## Data Sheet Supplement

### Differential Two-Wire Hall Effect Sensor IC      TLE 4942-2 TLE 4942-2 C

For all parameters not specified in this document the TLE 4942 data sheet is valid.

**Fig. 1: example for start-up behaviour**

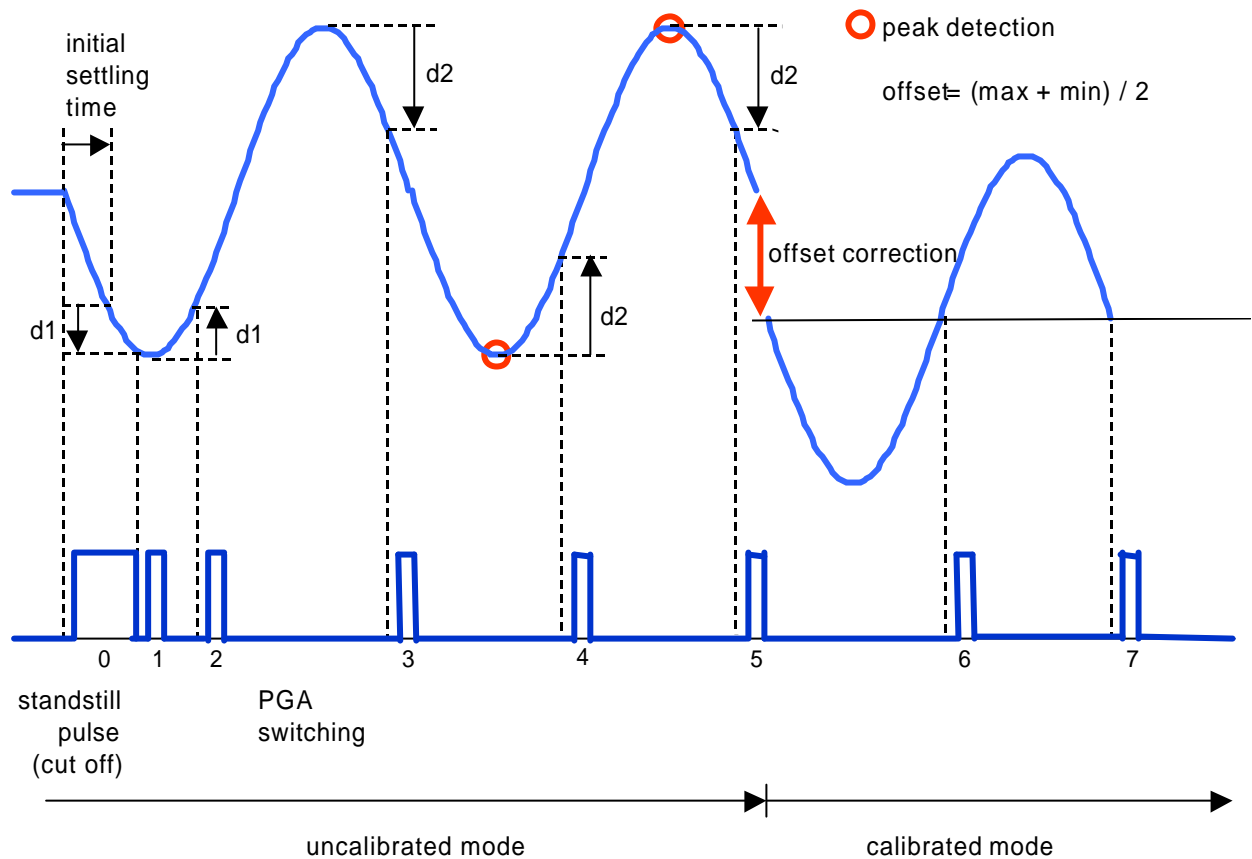
Unlike the TLE 4942 the first output pulse might occur before the first zero-crossing of the magnetic input signal. Therefore the maximum number of edges until the calibrated mode is active is increased by one for TLE 4942-2. However, referring to the input signal the delay between startup of the signal and first calibrated output signal is identical with TLE 4942.

Typically the phase error due to PGA-transistion (row 7 to 15) reduces the error caused by switching the mode from uncalibrated to calibrated.

In very rare cases a further PGA switching can occur during the calibration process. It can take place when the signal is extremely close to a PGA switching threshold. This additional switching might delay the transition to calibrated mode by two to three more pulses. The probability of this case is mainly depending on variations of magnetic amplitude under real automotive conditions. (See appendix B)

The direction detection feature is active in the calibrated mode only. Therefore identical to TLE 4942 the correct direction information is available after the first three output pulses in calibrated mode. Regarding the rare case mentioned before combined with other initial conditions this may lead to a worst case of 11 pulses before correct direction information is guaranteed. The typical value is 5 pulses.
